A G E N D A

Architectural Review Board

October 23, 2018

1265 South Lawrence Street

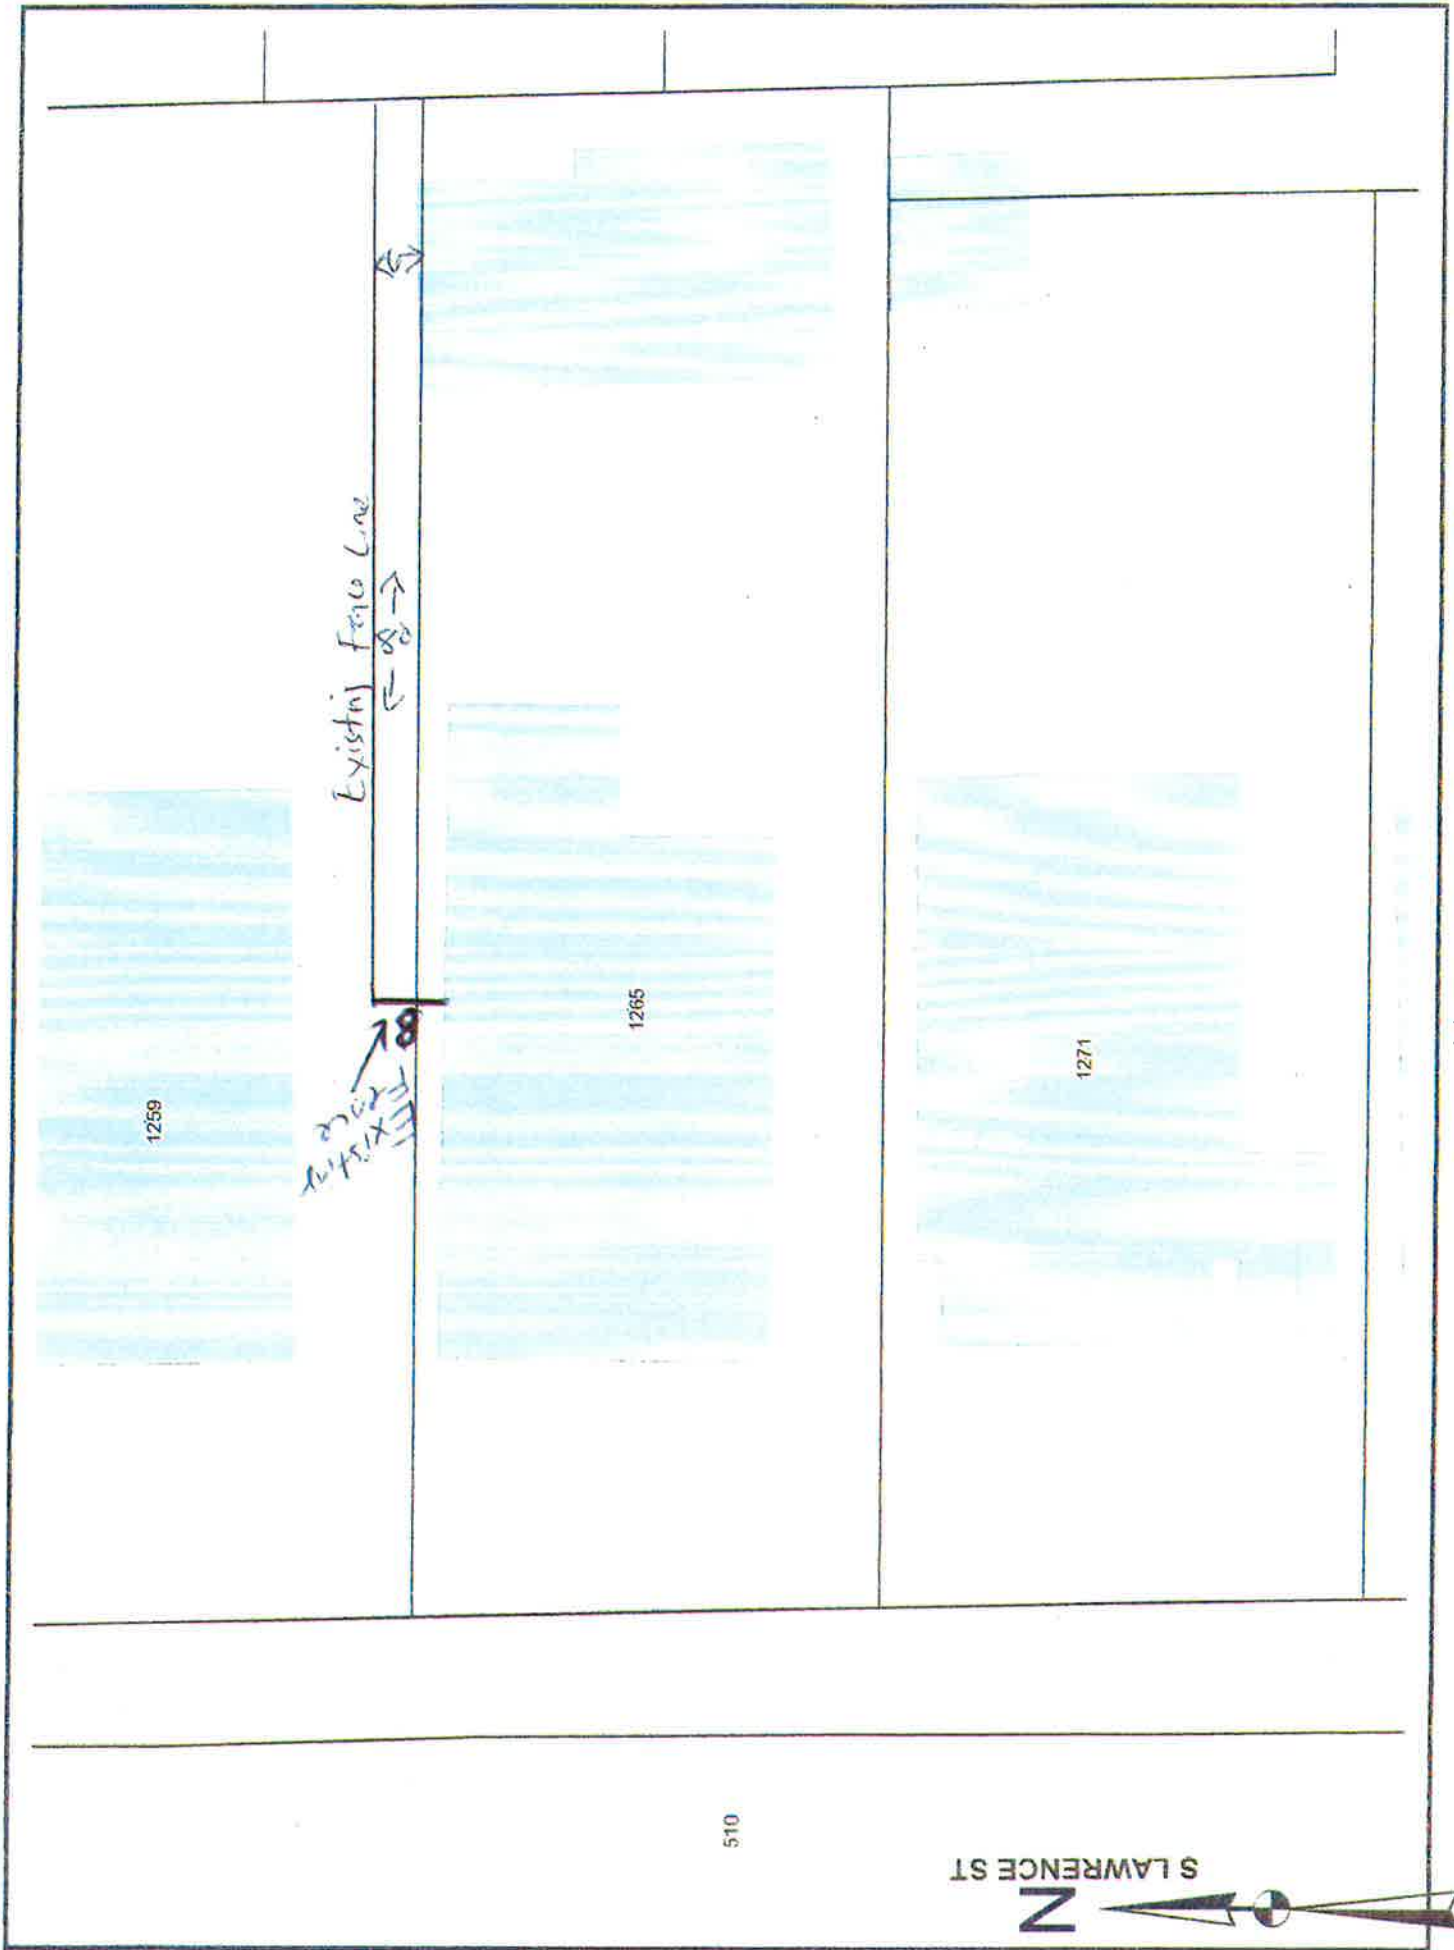
REMARKS: The petitioner is requesting permission to install a burnished slate 5 v crimp metal roof on the existing outbuilding; and reintroduce a 6' privacy fence along the property line where it appears there once was a fence that is no more. All other proposed work on the property involves making repairs and replacing materials in kind.

- The Board has approved metal roofs on outbuildings, and Burnished Slate (a dark brown/gray) has been one of the more common colors.
- Privacy fences have routinely been approved in rear yards.

1343/1347 Felder Avenue

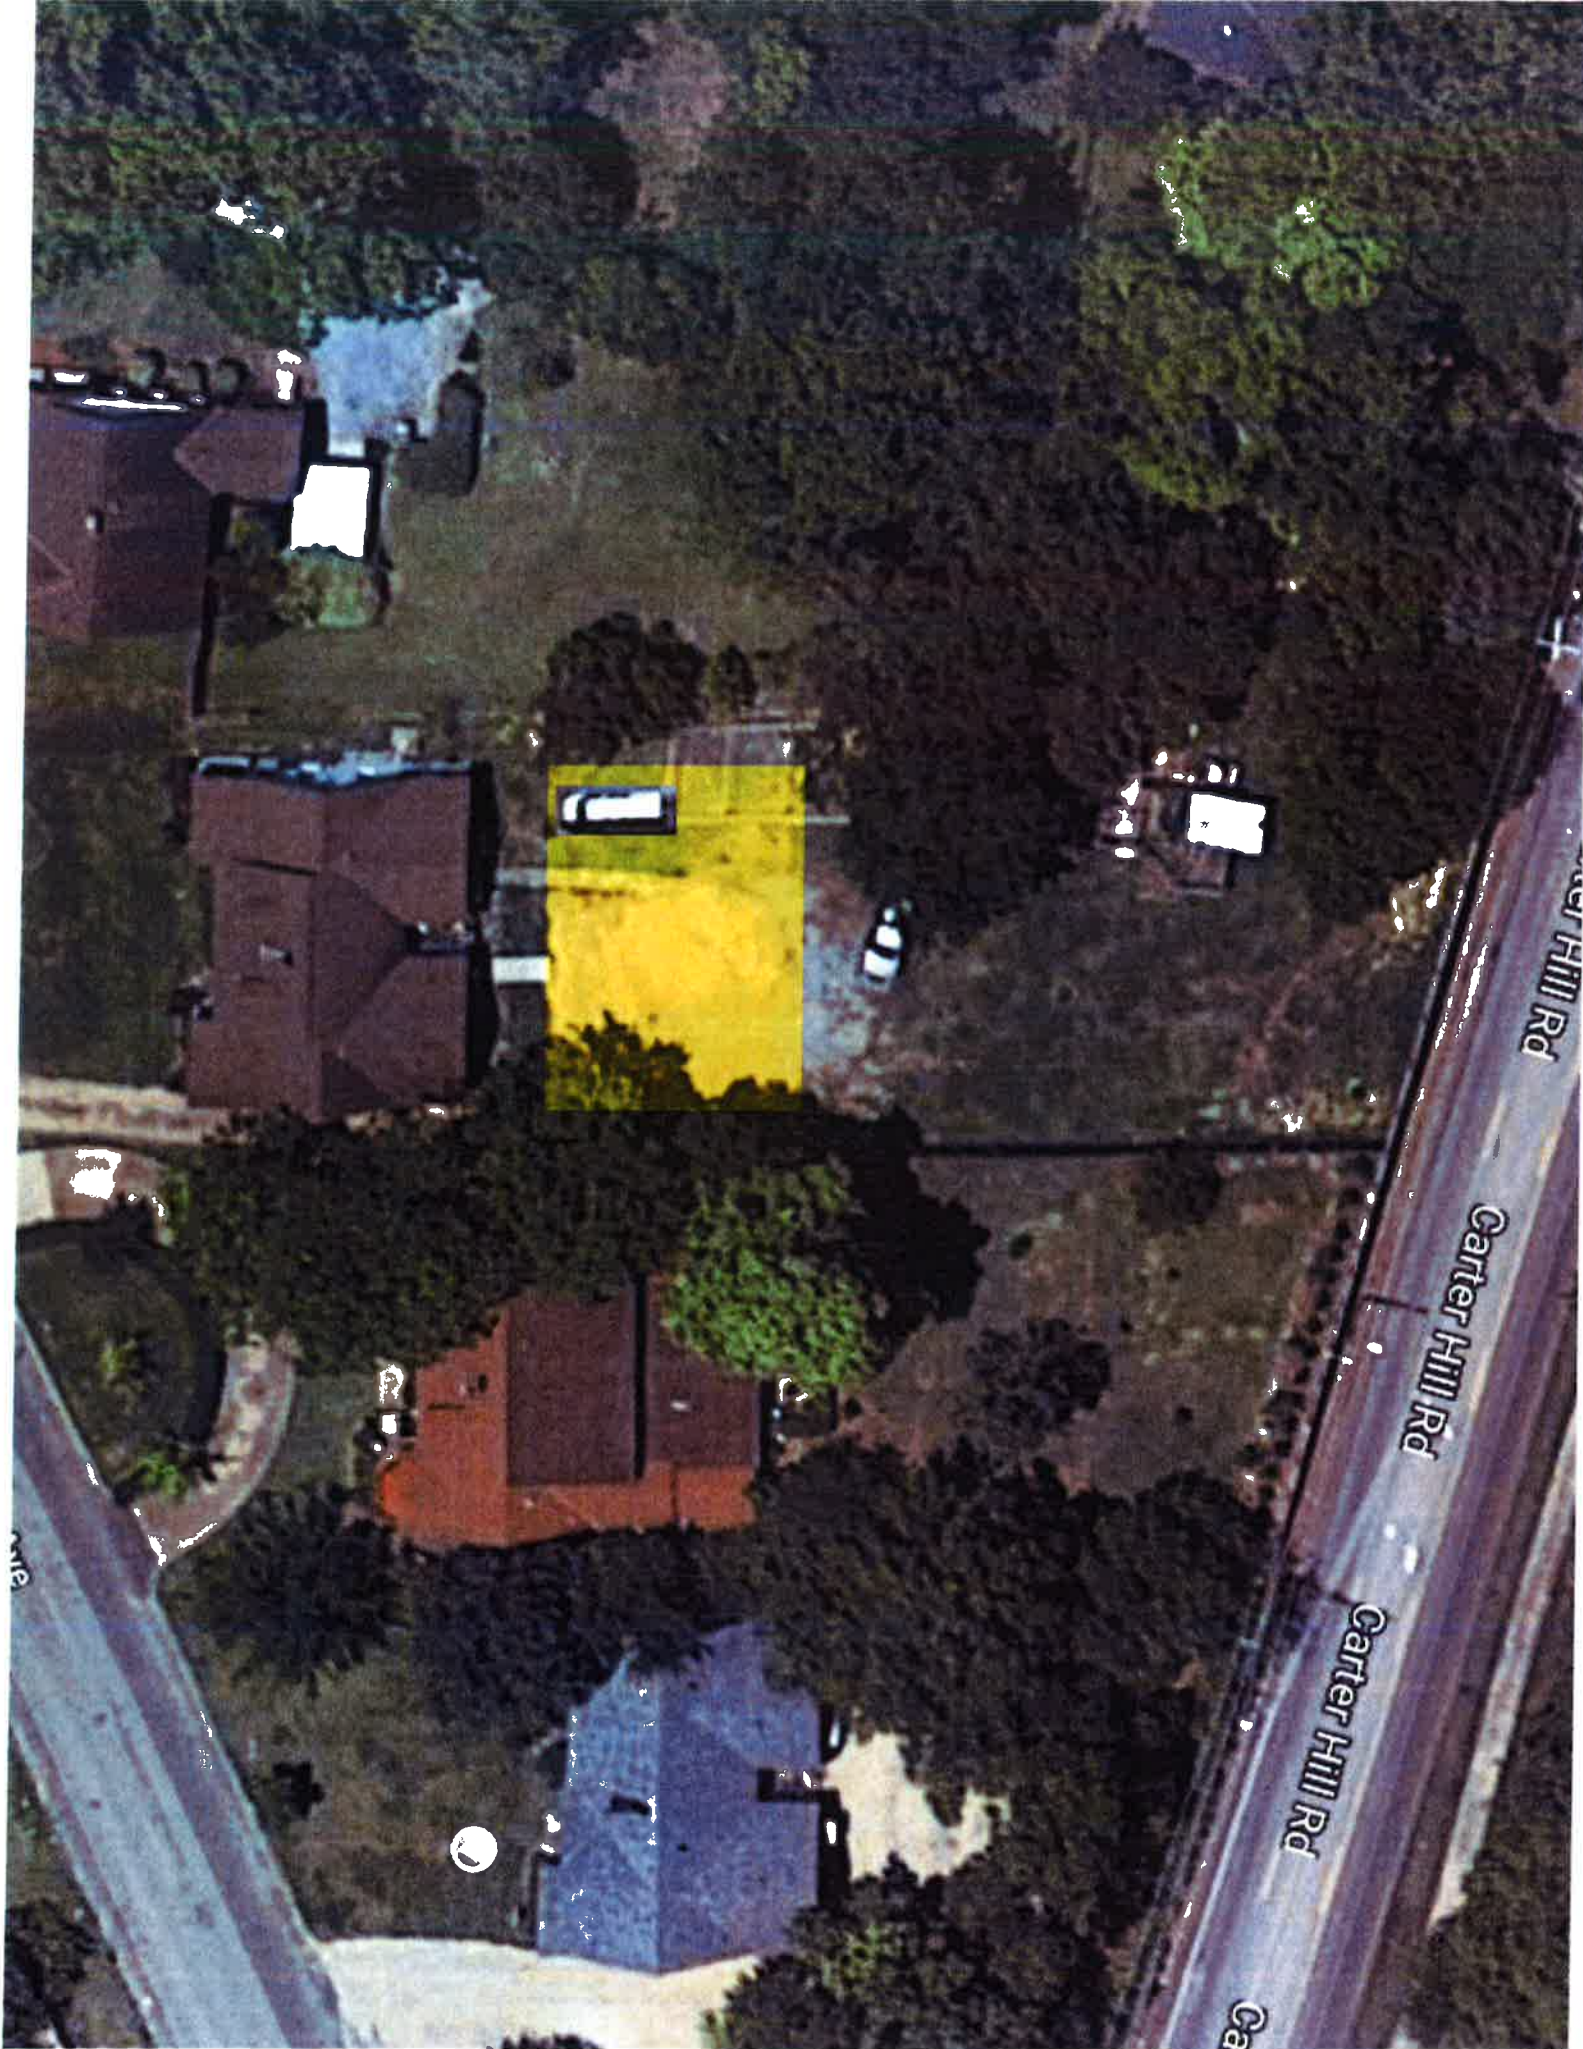
REMARKS: The petitioner is requesting permission to install a plain steel porch railing on the front porches (illustration attached), and to expand a rear yard parking area to approximately 40'x40' to accommodate 4 vehicles. The surface will be gravel and edged with Terrace Board to contain the gravel and prevent gravel creep.

- The Board has approved gravel parking areas as long as they have some sort of boundary/edge that will keep the gravel contained. Parking in the rear is always preferable to parking in the front yard.
- The metal railing is an inconspicuous option for the porch.

3184 Lexington Road Fence, Garage Door

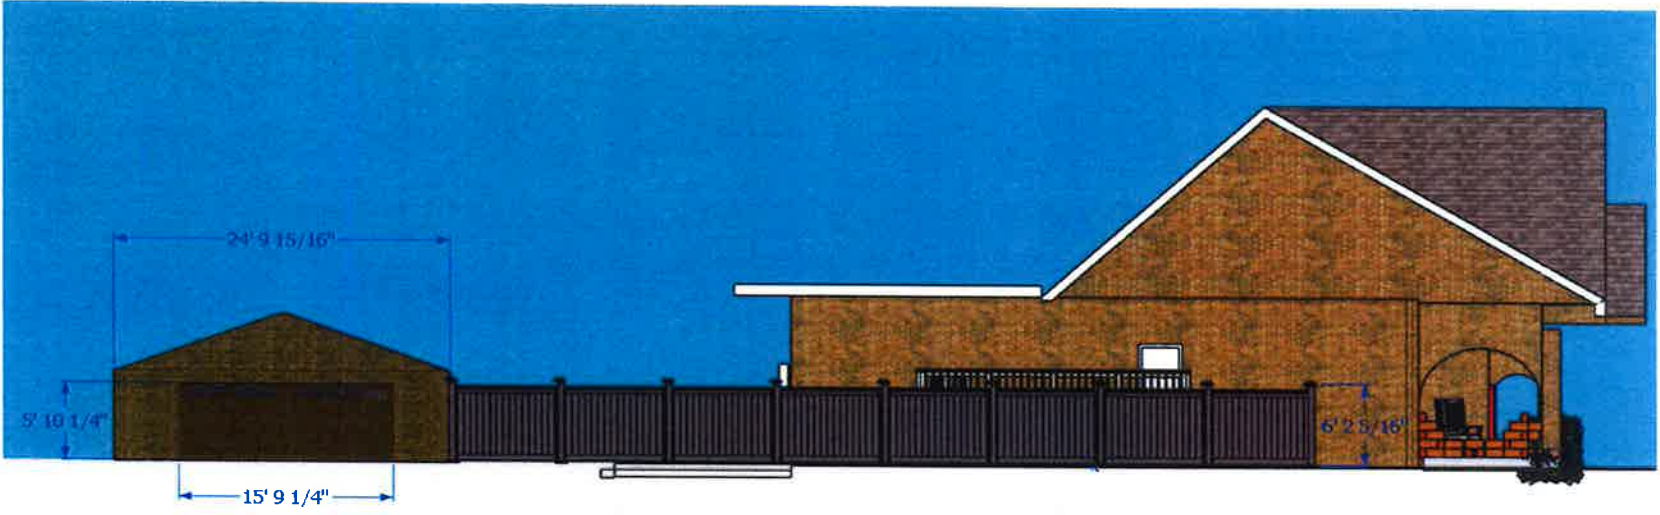
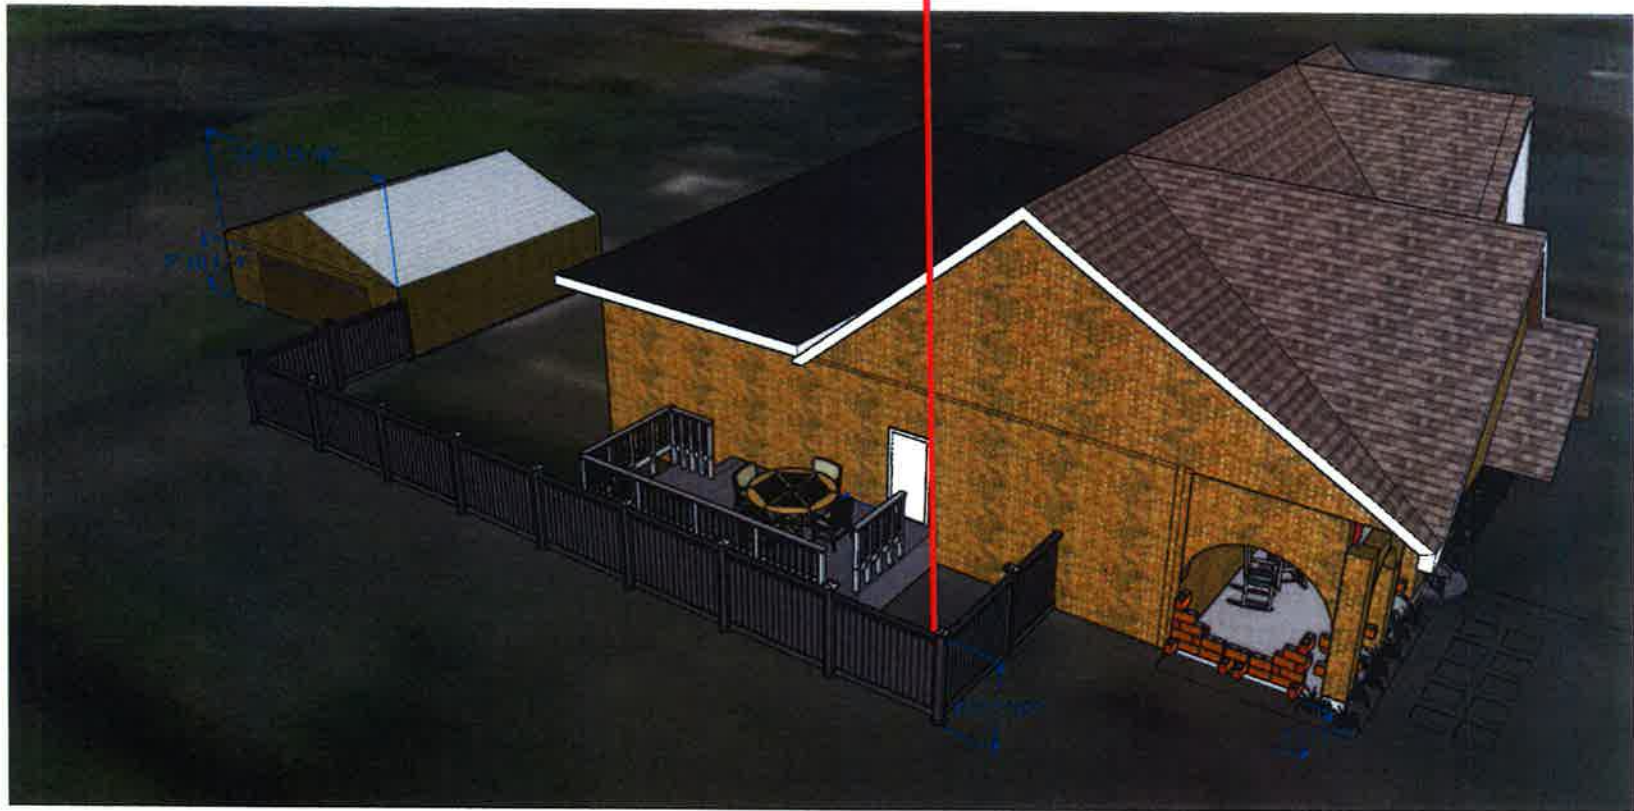
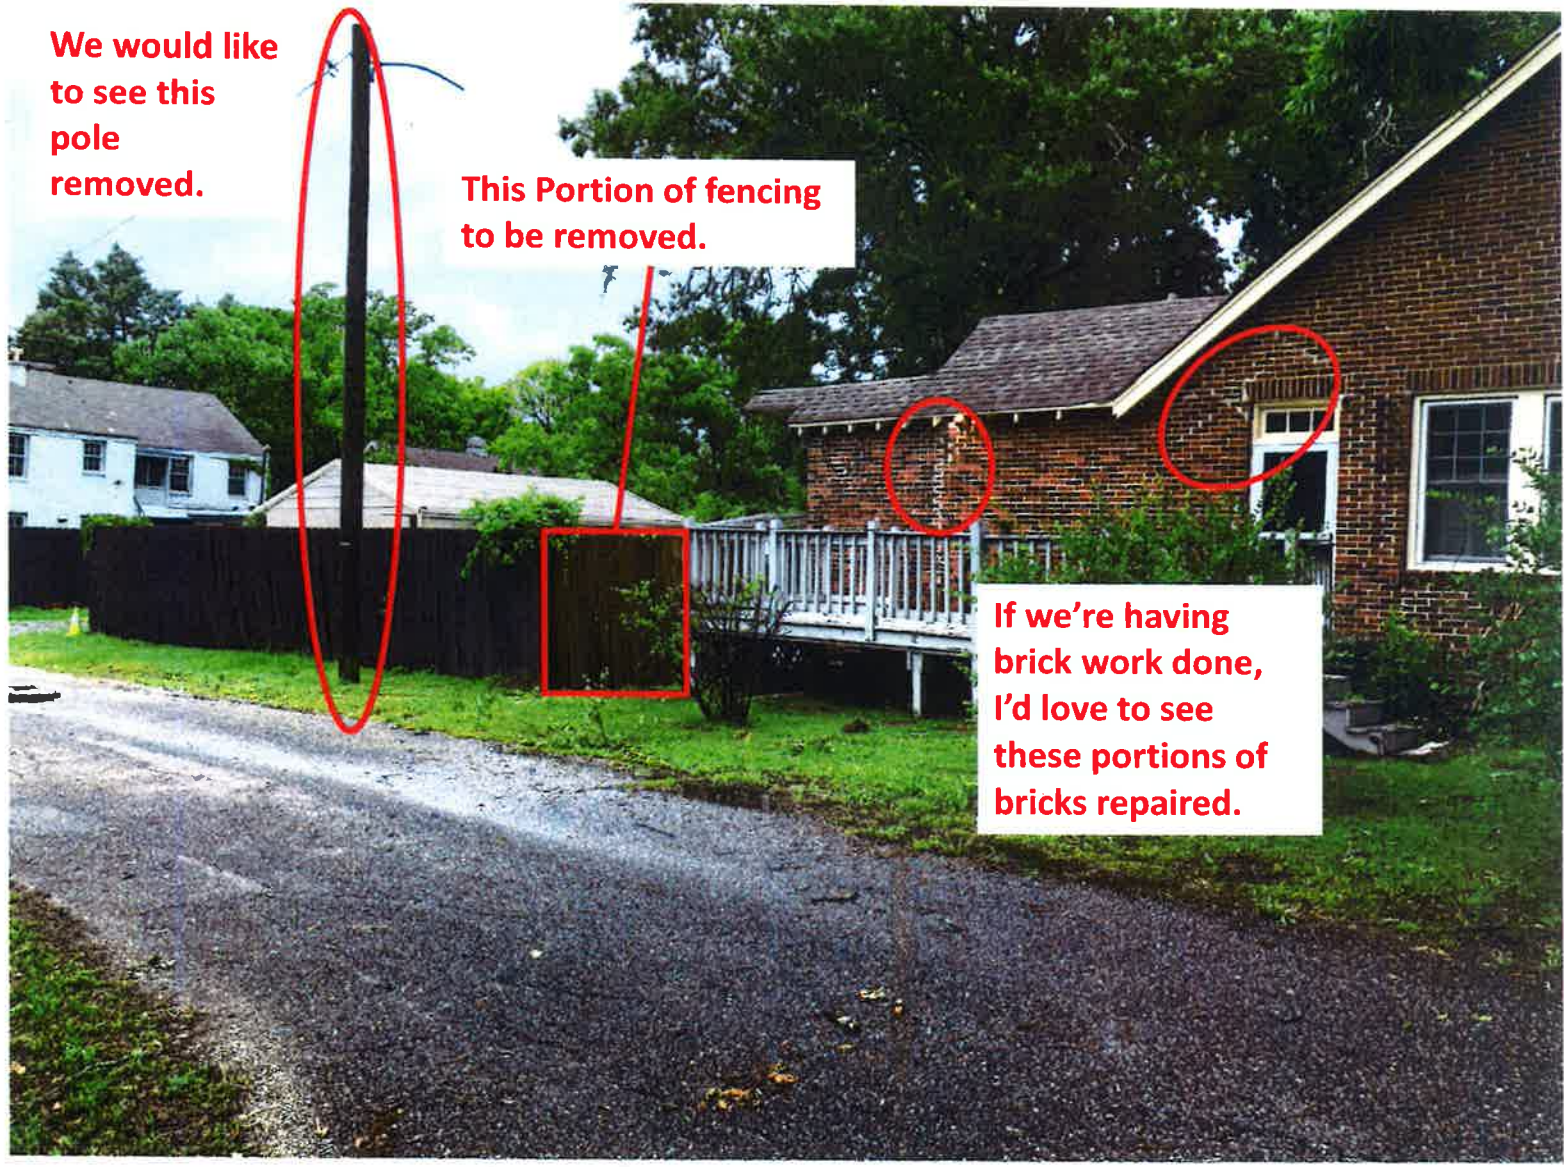
- Replace the existing fence with a new 6' wood fence in the style shown, and extended to enclose the side deck (to be repaired)
- Replace the existing garage door on the metal building with a new steel door in the style shown
- Apply a brick veneer on metal garage in a color to match the existing house. Gutters will be installed at the roof to help mitigate the transition from the roof to the walls.
- Proposed removal of the utility pole is out of the ARB's purview.

- A variance is required for the fence if none is on record.
- In my time staffing the Board, we have not reviewed a request to veneer a building. The building in question is a non-historic metal building. The Board was presented with a foam brick several meetings ago as an advisory materials review, at that time the Board suggested the owner consider painting the building a dark color so that it would disappear into the background.
- The Board has approved steel garage doors.

This Portion of fencing to be removed.

NEW FENCE LINE

Proposed Extension of Fence

We will put a garage door here,
so perhaps, it may make sense to leave this open
And build a carport.

Garage to be bricked and covered.
